SAMSUNG

SUBJECT: Top Loader Unbalanced During Spin Cycle

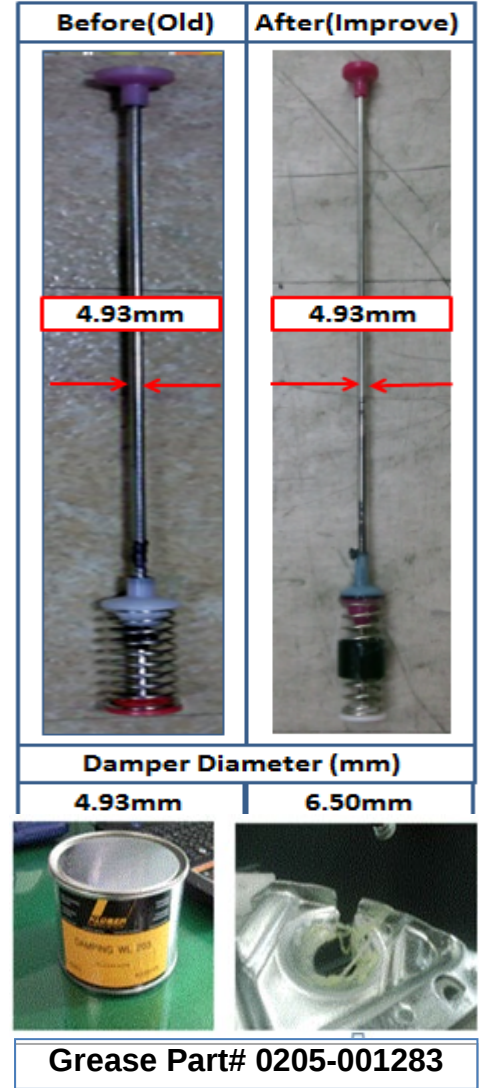
- UE/DC Error Displayed
- Unit unbalanced during spin cycle

If the unit displays Unbalance or a DC/UE error, you must install the **New ASSY DAMPER (DC97-05280W)**.

- ❖ You must order 4 new ASSY Dampers, one for each corner of the washer.
- ❖ You must apply grease to the top of the new ASSY Dampers.
Failure to apply grease to the top of the new ASSY Dampers will result in noise and vibration issues!
You can use grease part# 0205-001283 for multiple customers.
